Carencro City Hall Expansion 2026
City of Carencro

Carencro City Hall Expansion

- d. The contract documents were submitted to third party review and inspection agency for the City of Carencro, Building Code Inspection Services LLC (Cooney Richard), for review. Comments were received on February 26, 2026. Those comments are hereby made part of the contract documents. The contractor shall comply with ALL requirements in the Commercial Construction Plan Review report dated February 26, 2026. See Attachment No. Two (2).

- e. The contract documents were submitted for review to the City of Carencro, who in turn engaged the City Engineer, C. H. Fenstermaker & Associates, LLC. A review letter dated March 13, 2026, was received on March 18, 2026. Those comments are hereby made part of the contract documents. The contractor shall comply with ALL requirements in the Fenstermaker Plan Review letter dated March 13, 2026. See Attachment No. Three (3).

Designed: CMR	Project No.: RAGIN NO. 1066
	Drawn: CMR	Scale: AS NOTED
	Checked:	Drawing No.: C.1R
	Reviewed:	Date: MARCH 18, 2026

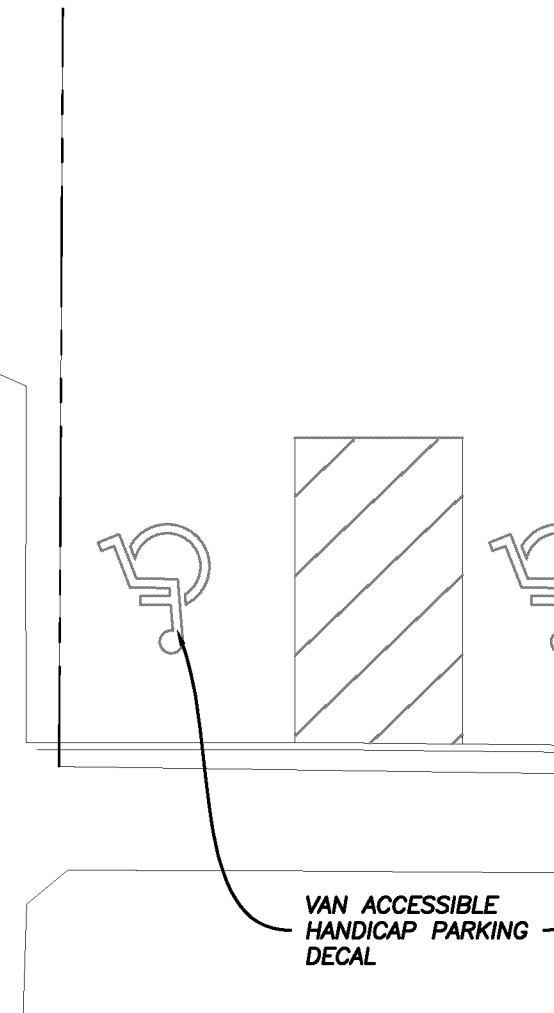
1. Plan Sht. C.1 – Civil Site Plan:
 - a. Post expansion square footage of building stated as 11,381 Sq. Ft. On-site parking provided = 32 spaces. Remainder of required parking based on building size (46 total), provided by on-street parking.

- d. Add truncated domes (w/ detail) to sidewalk tying into S. Church Street.
 - e. Provide wheel stop for parking stall adjacent to sidewalk access to existing pavilion.

- b. Clarify discrepancy in total number of parking spaces provided on Civil and Arch Sheets. (Civil – 32; Arch – 31).
10. Topographic & Boundary Survey:

- a. Sheet G.000 –
 - i. In the “Building & Site Parameters” located near the center of the page, the Total Parking number is hereby revised to “32 spaces”. See C.1R for more parking spaces information.

JOINT DOWEL BAR SIZE CHART

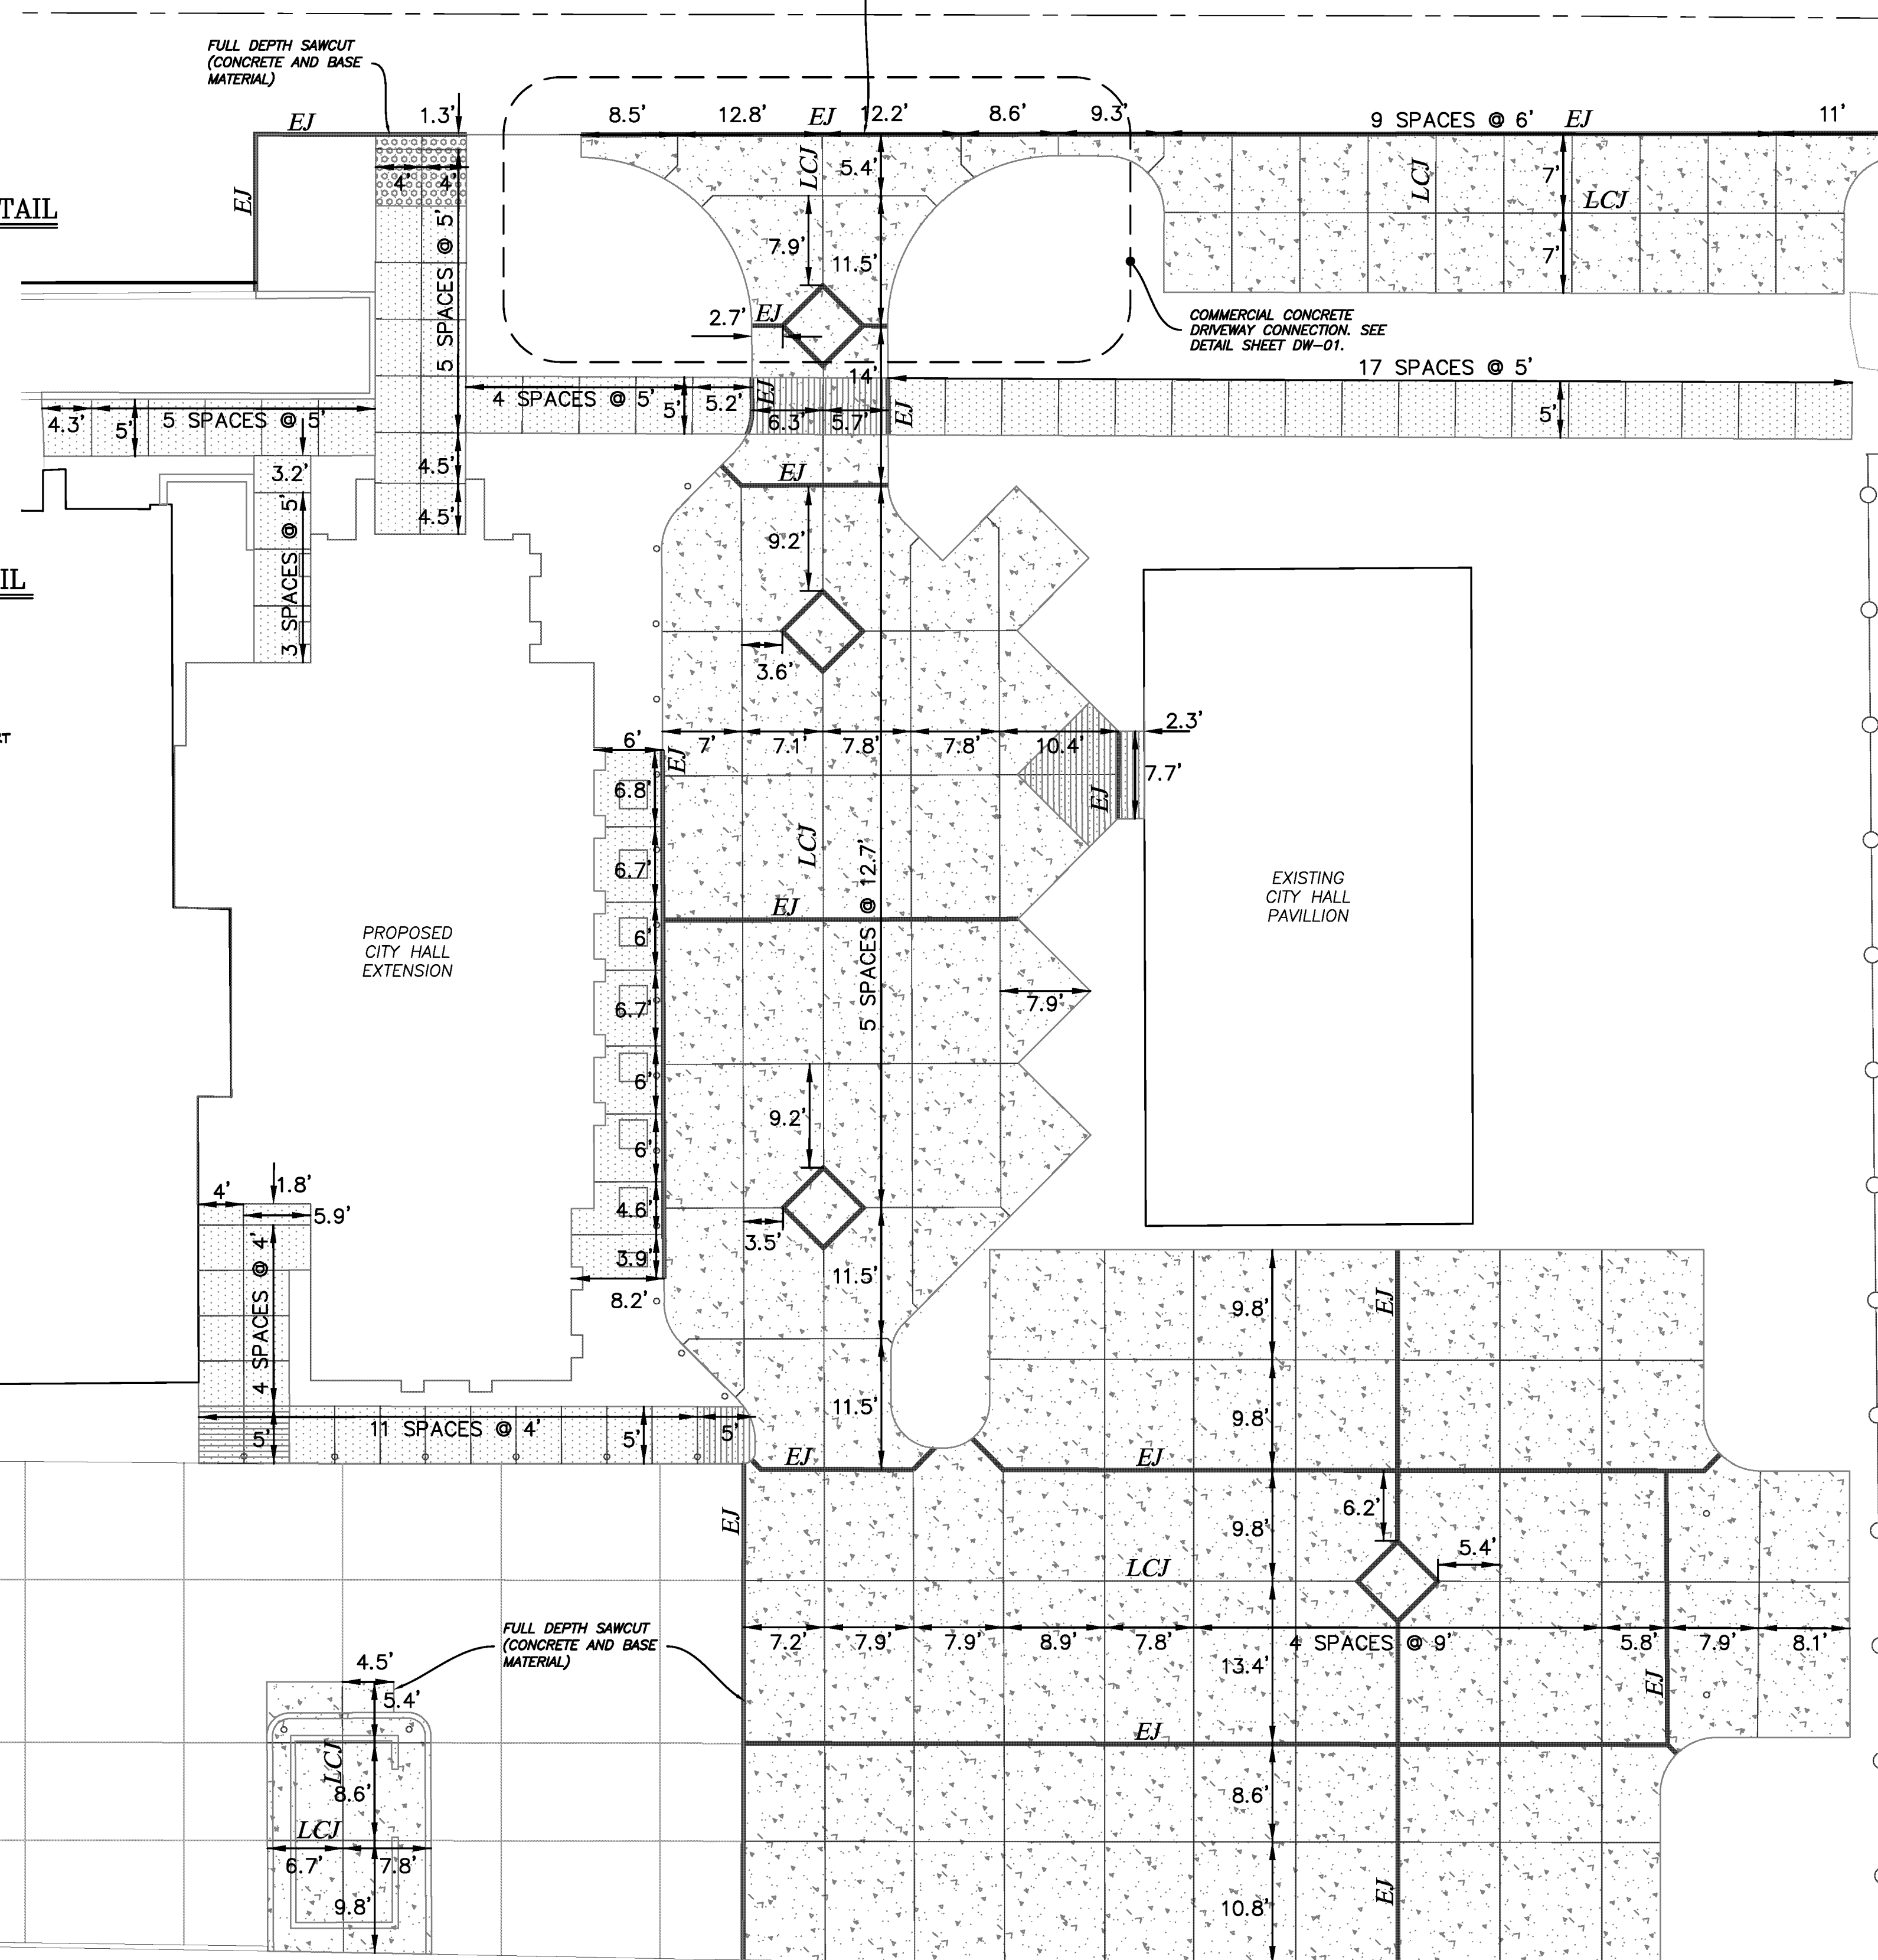
4. Plan Sht. C.7 – Joint Plan:
 - a. Note No. 2 referring to sawed joints conflicts with note about not using sawed joints by the joint dowel bar table. Compare the notes and revise accordingly.

EROSION CONTROL PLAN

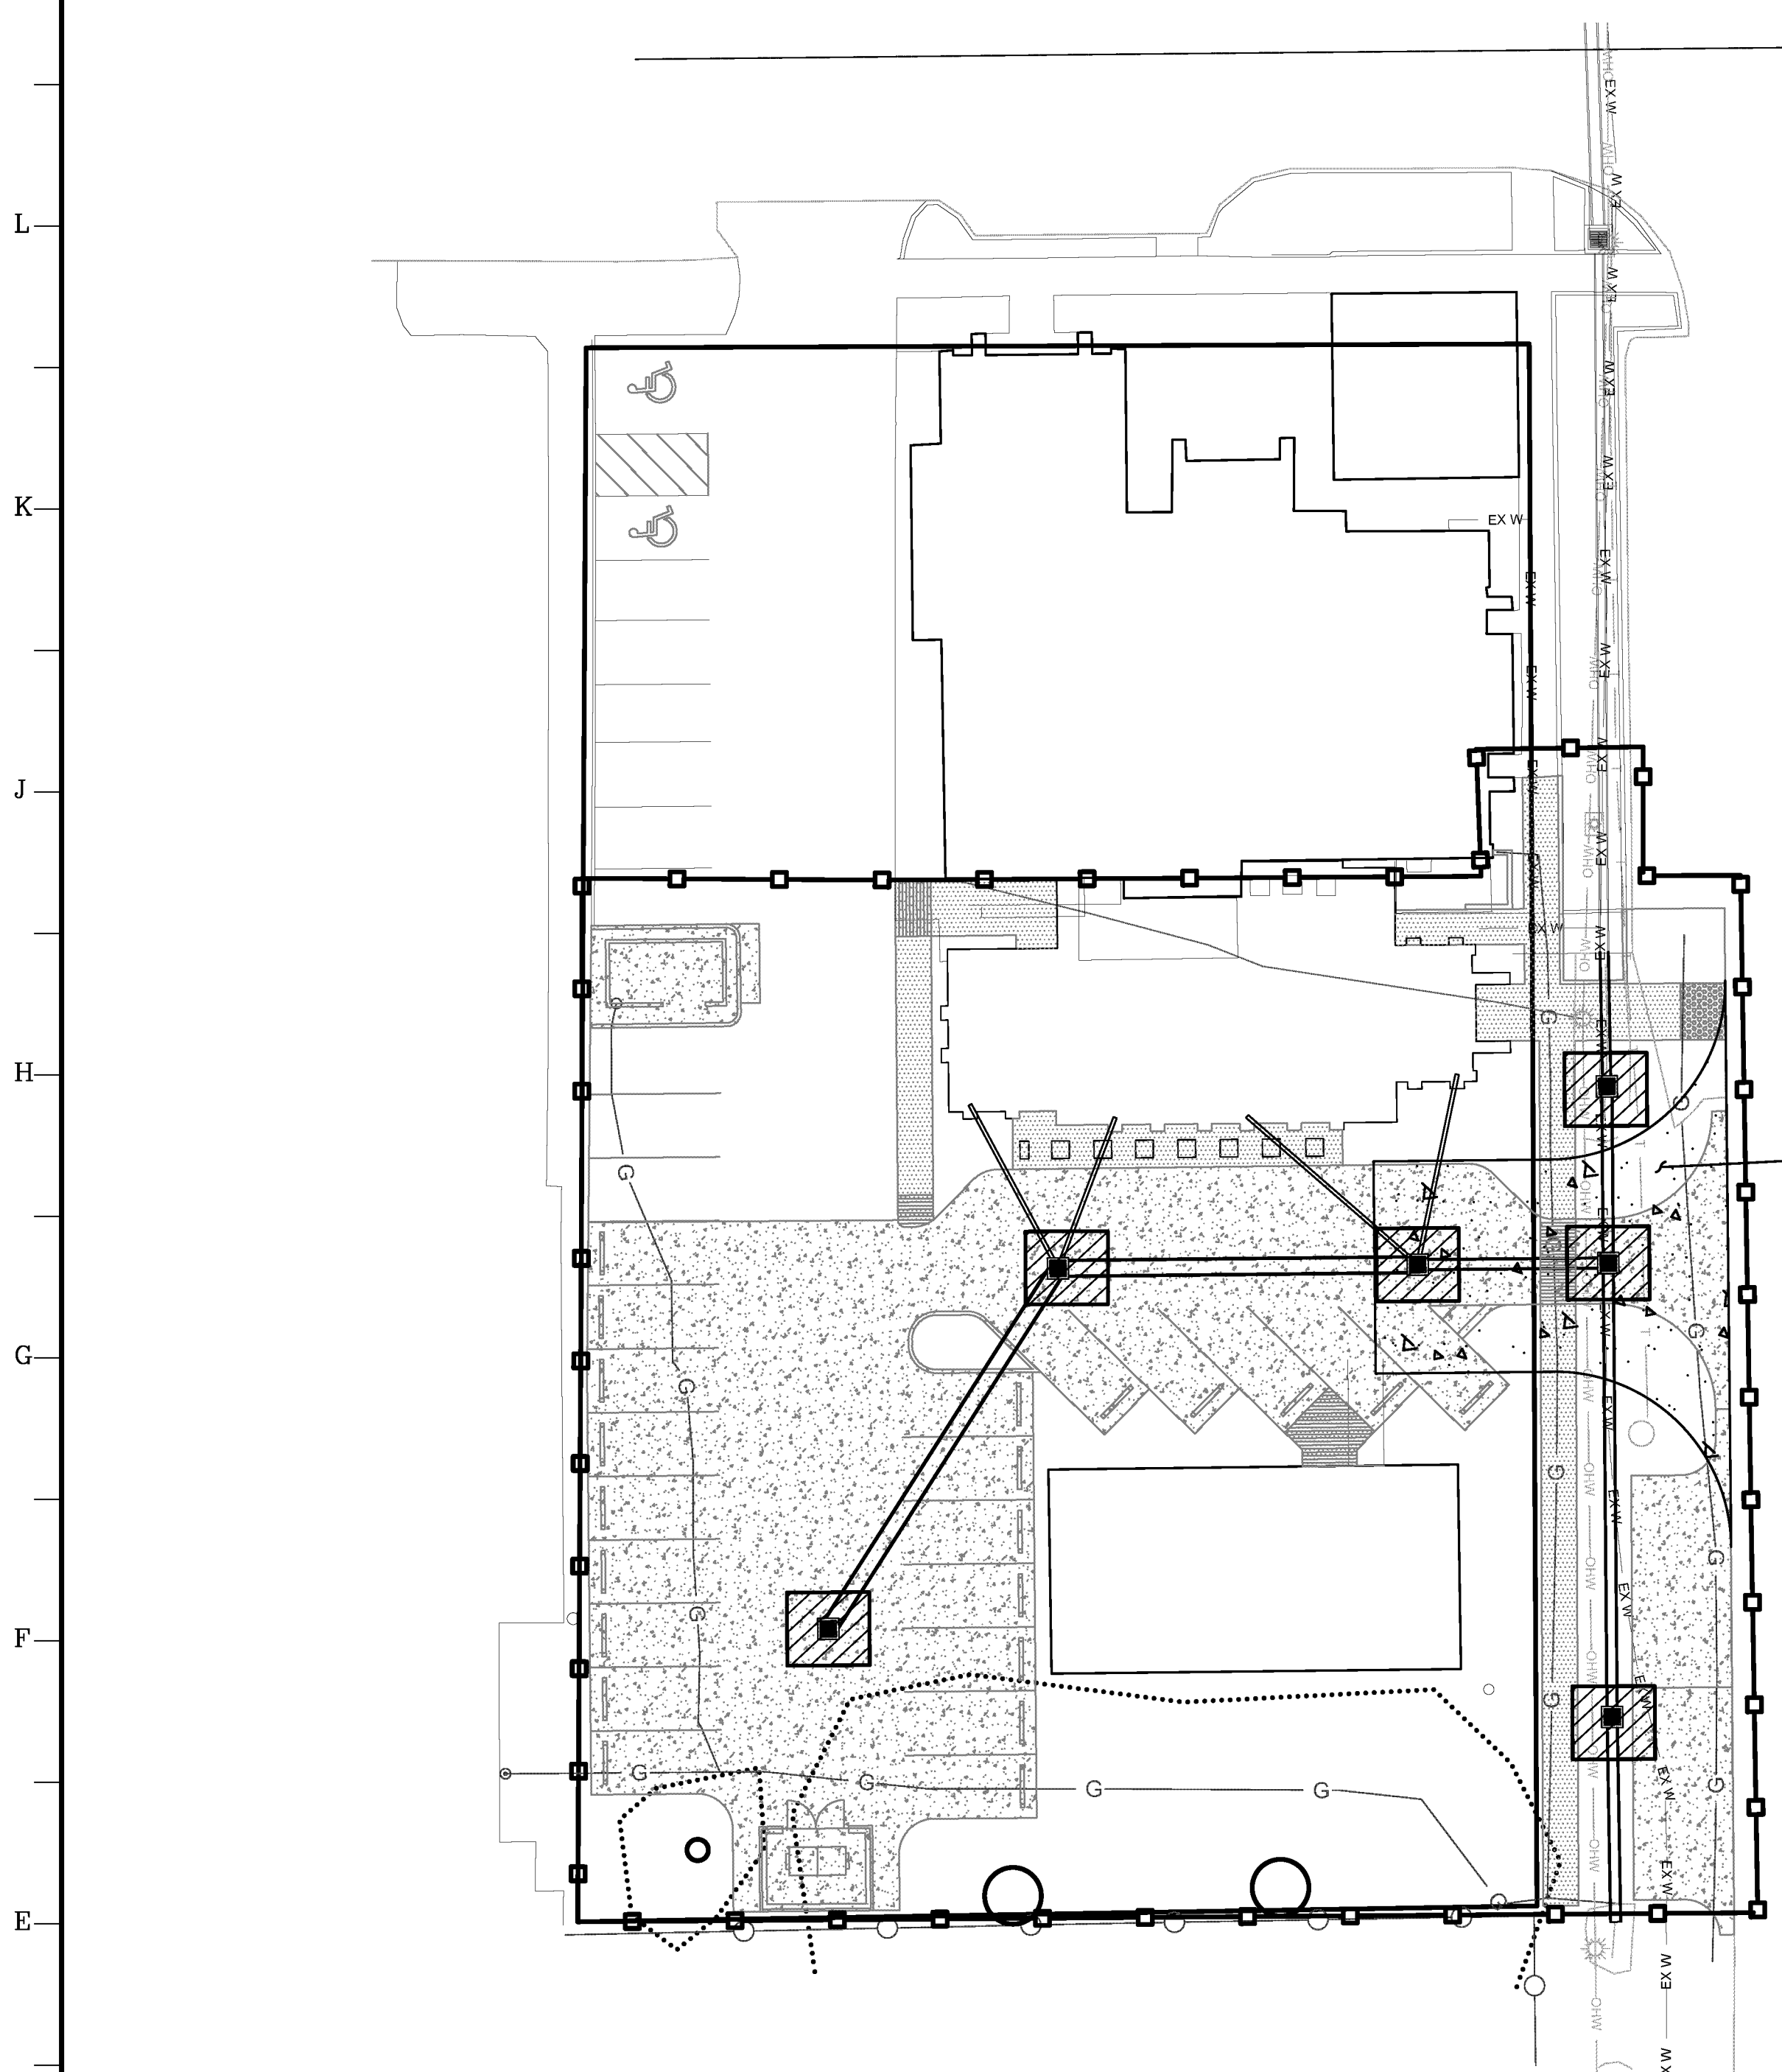
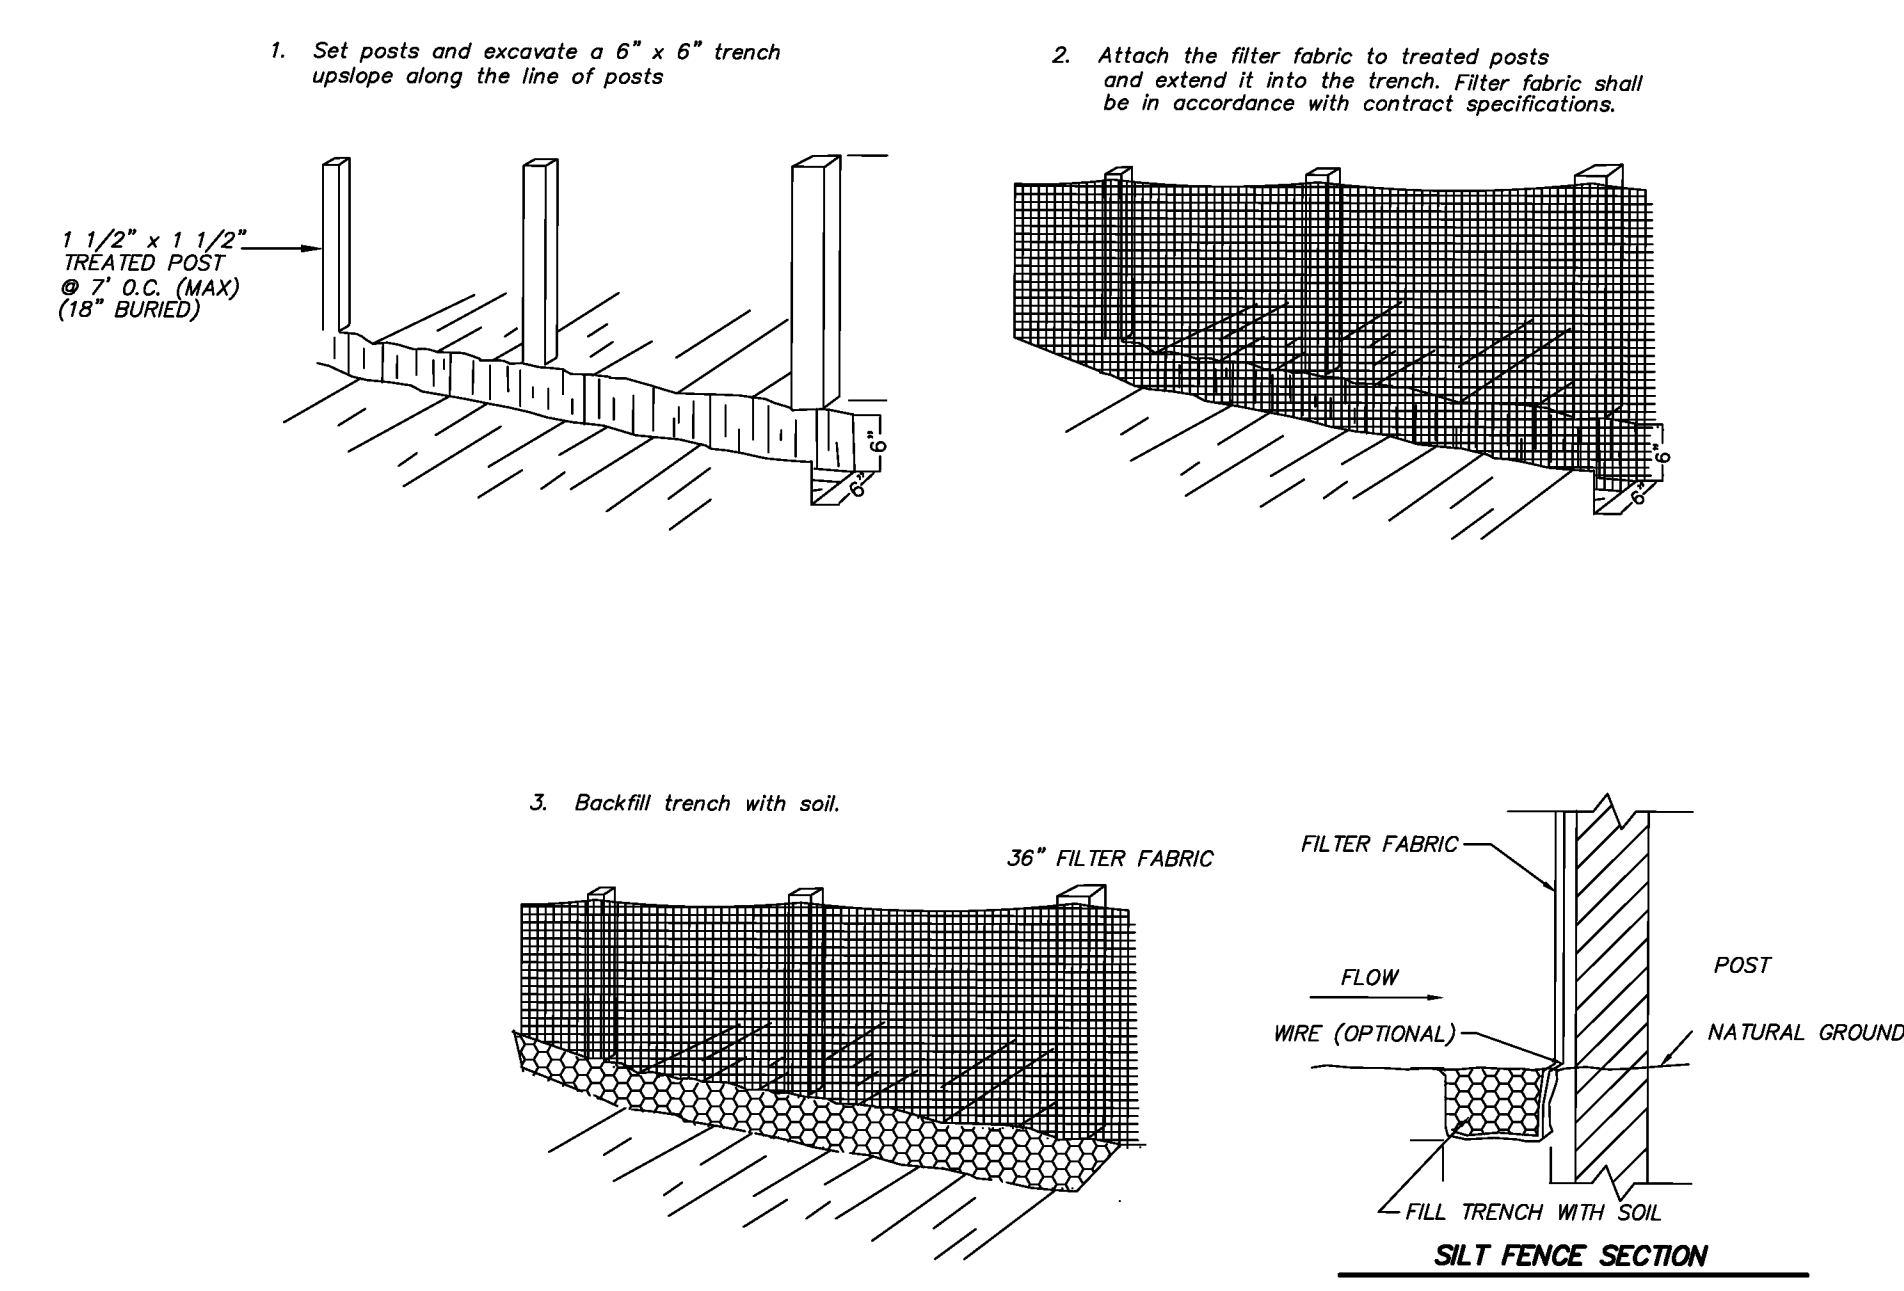
5. Plan Sht. C.10 – Erosion Control Plan:
 - a. Provide location and detail of Stabilized Construction Entrance.
 - b. “Pond” notes do not apply to this project. See Erosion Control Note No.7 and site drainage note about ponds.
